Proposed Revisions to a Standard Plans Index

Index Number: 700-041

Sheet Number (s): 1, 2, and 5 of 5

Index Title: Span Sign Structure

LAST REVISION	11/01/22	DESCRIPTION:		FY 2022-23 STANDARD PLANS	SPAN SIGN STRUCTURE	INDEX 700-041	SHEET 1 of 5
---------------	----------	--------------	--	------------------------------	---------------------	------------------	-----------------

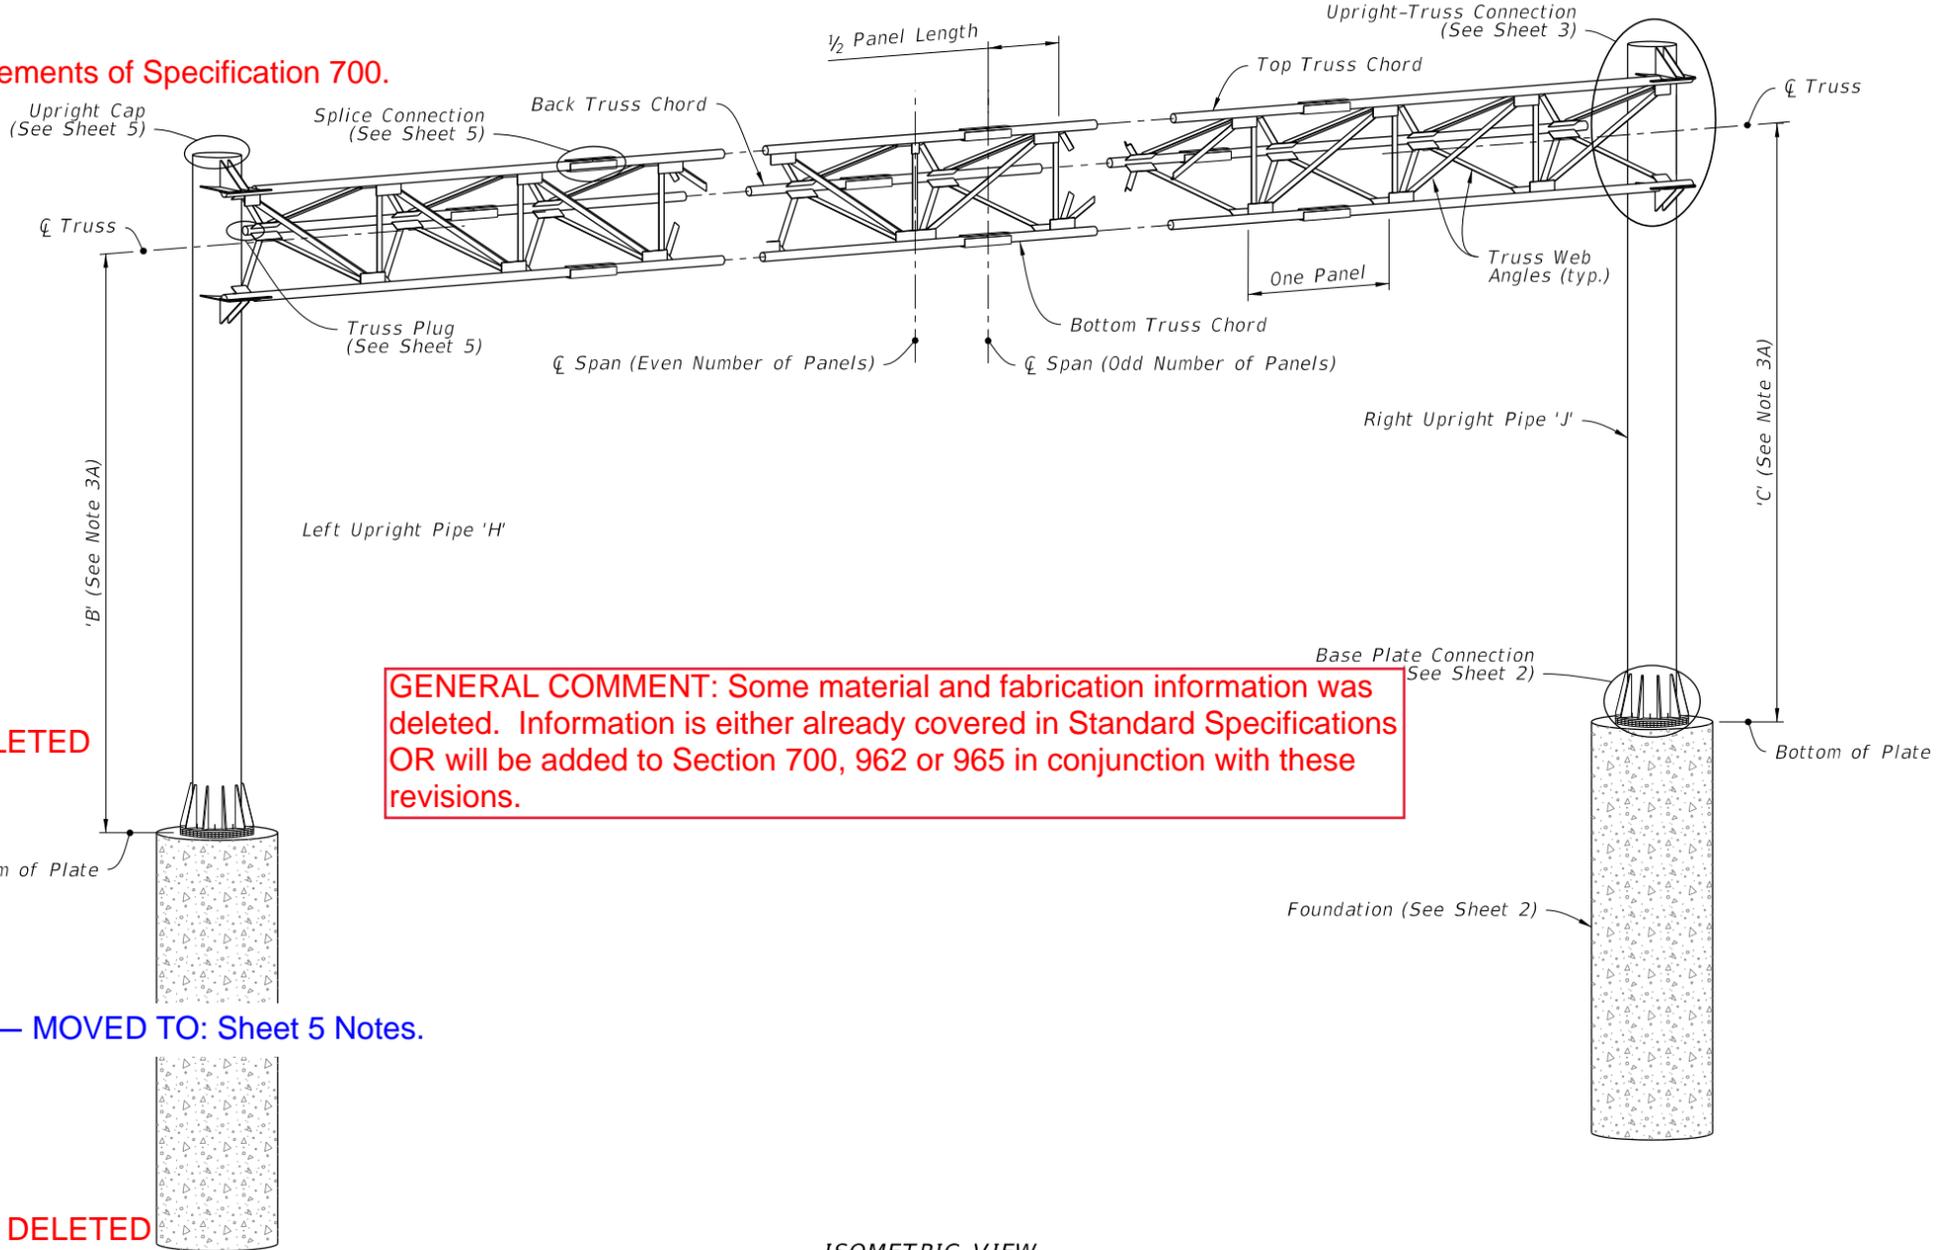
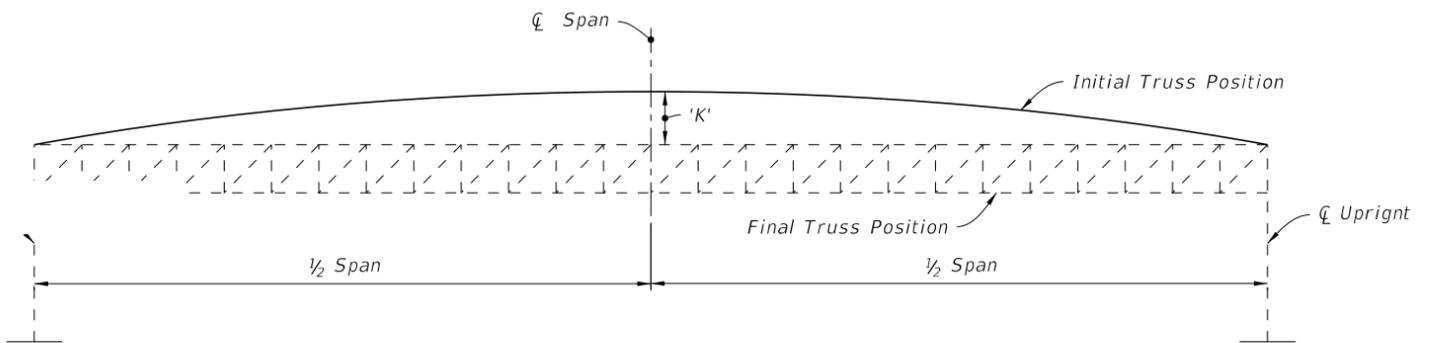
Sheet 1: Updated Notes to General Notes; Added New General Note 1 - "Meet the requirements of Specification 700"; Deleted Notes 4 through 7; Moved Note 5.B and 5.C to Sheet 5 Notes; Renumbered Notes.

ADDED NEW NOTE 1: Meet the requirements of Specification 700.

UPDATED: GENERAL NOTES:

- 2. ~~Work this Index in conjunction with SPAN SIGN STRUCTURE DATA TABLES in the Plans and Index 700-030.~~
- 3. ~~Handholes at the pole base are required for DMS Structures. Refer to Index 700-090 for Handhole Details.~~
- 4. ~~Shop Drawings are required.~~

GENERAL COMMENT: Some material and fabrication information was deleted. Information is either already covered in Standard Specifications OR will be added to Section 700, 962 or 965 in conjunction with these revisions.

DELETED

MOVED TO: Sheet 5 Notes.

BASE PLATE CONNECTION

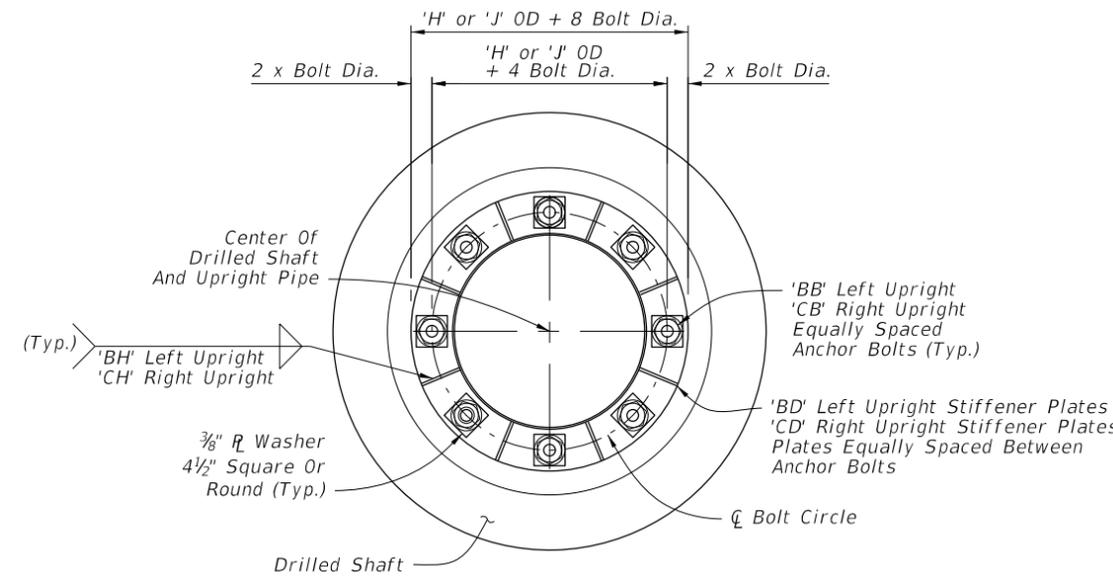
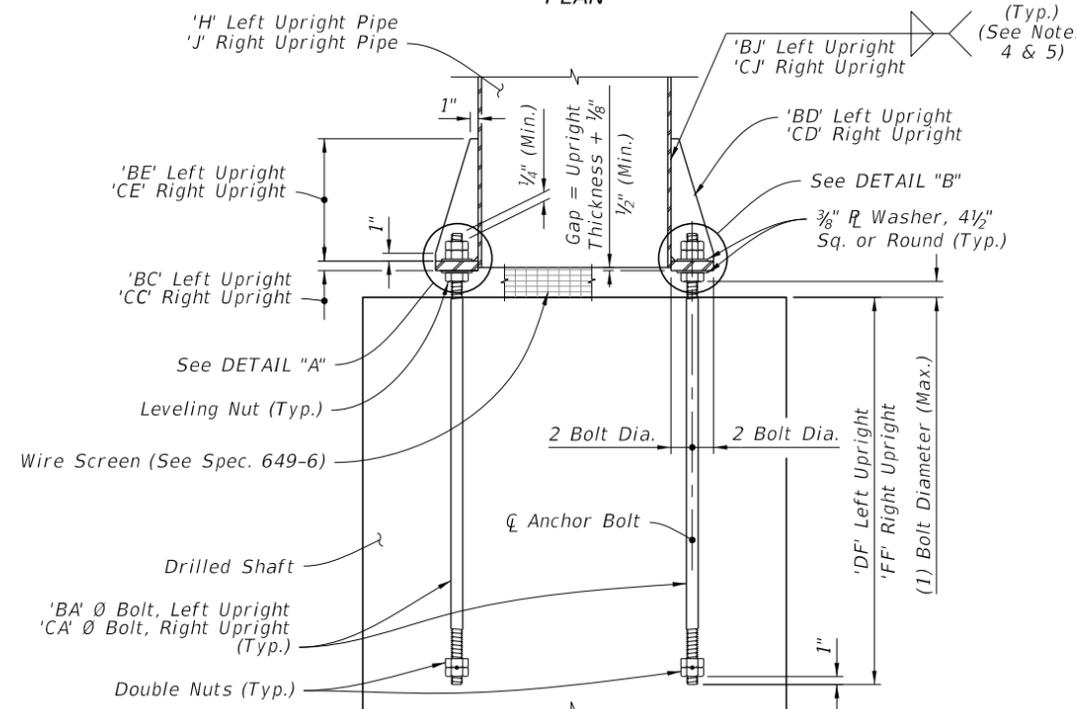
Sheet 2: Added note 6 detailing the weld pattern of the 'BD' and 'CD' plates indicating that they should be welded in a star pattern.

6. **ADDED NOTE 6: 6. Weld plates 'BD' and 'CD' in a star pattern. A star pattern is one in which the plates on opposite and near opposite sides of the pole circle are successively welded in a pattern resembling a star. For an 8 plate circle with plates sequentially numbered 1 to 8, weld the plates in the following order: (1, 5, 7, 3, 8, 4, 6, 2).**

Sheet 2: This process is to help prevent residual stress buildup in base plate connection to prevent cracking.

ALTERNATE SPLICE CONNECTION DETAIL

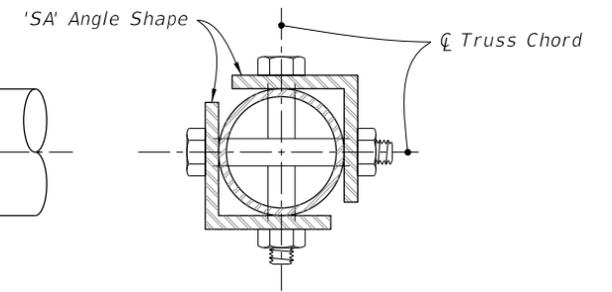
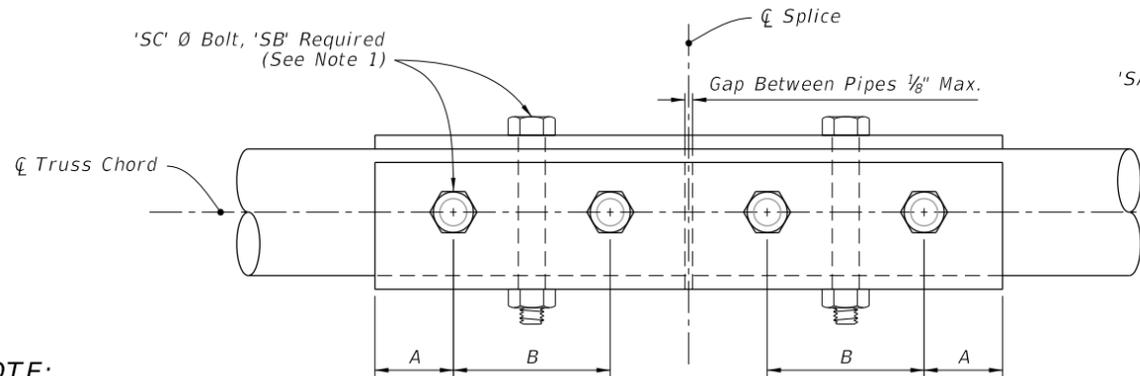
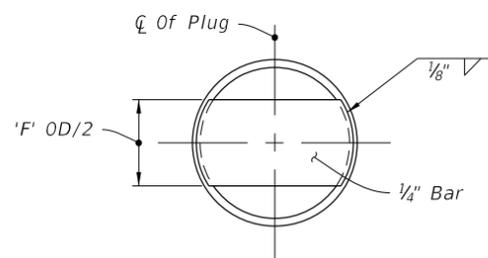
Sheet 5: Added General Note 5.B and 5.C as New Note 2 - "Chord Splices: Minimum splice spacing is three truss panel lengths apart and three truss panel lengths from the uprights when panel lengths are 10'-0" or less. Chord Splices may be either the Standard Splice or the Alternate Splice, but not both on the same structure." and Note 3 - "Upright splice: Not allowed unless the upright exceeds available mill lengths (35' - 40')."

ADDED NOTES 2 AND 3:

2. Chord Splices: Minimum splice spacing is three truss panel lengths apart and three truss panel lengths from the uprights when panel lengths are 10'-0" or less. Chord Splices may be either the Standard Splice or the Alternate Splice, but not both on the same structure.
3. Upright splice: Not allowed unless the upright exceeds available mill lengths (35' - 40').
